## Service Bulletin #2003-141

**Applicability:** Ribley Chairlifts using weight-set hydraulic Drive Sheave ("Emergency") Brakes, #4039 with single-reduction (621, 631, 641) Caterpillar planetary hubs and #4081 with pre-1974 F-section drive terminals.

**Subject:** Improved solenoid valve; faster brake retraction and reset.

TITLE  
VALVE FOR #4039 OR #4081 E-BRAKE

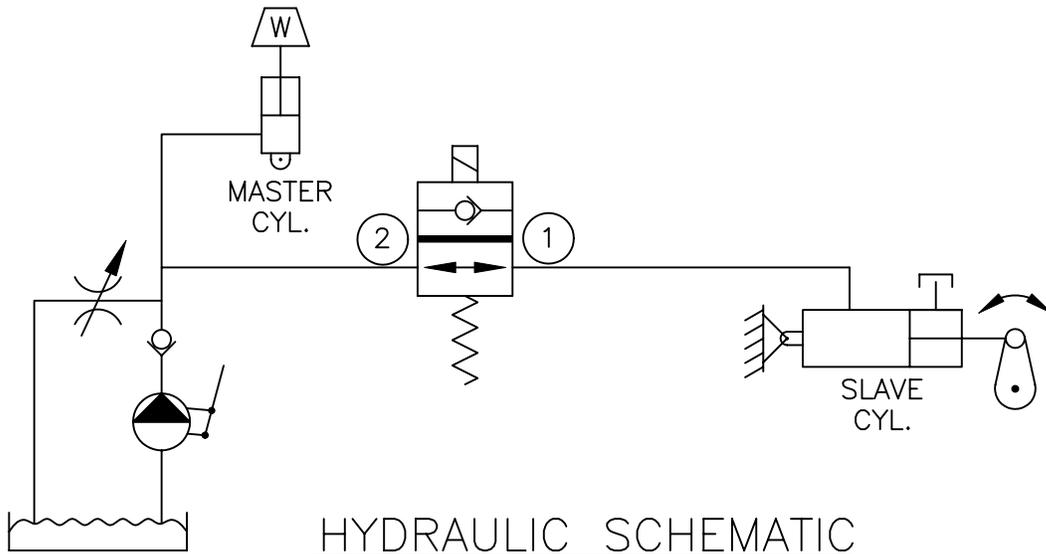
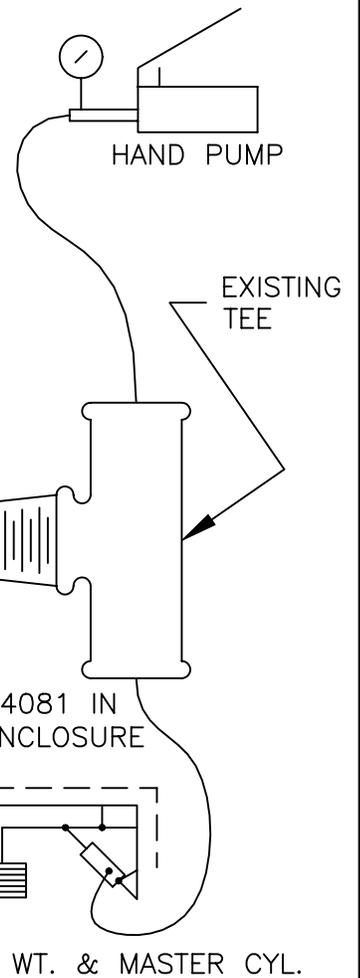
These brake systems work very well, but they have one annoying characteristic: when re-setting the system after brake application, the spring-loaded slave cylinder(s) must fully retract before the system can be pumped up. This retraction can be quite slow, as the pilot ports in the 2-way poppet-type solenoid valve restrict reverse flow. We now offer a new valve and fitting kit which makes retraction much quicker. Installation is just a matter of replacing the old valve with the new.

Call our parts department now to order brake valve kit #A08488. Most are 12 volt; tell us if you need 24 volt. Current price is \$126.19, f.o.b. Spokane. Delivery depends on our stock level. A drawing is attached showing installation of the kit.

NOTE:  
AFTER INSTALLING  
VALVE, TEST FOR  
CORRECT BRAKE  
SETTING TIME.

REPLACES RACINE MA-06-5-H-N-0-12VDC,  
AMBAC #5-039AA-4-A-12VDC
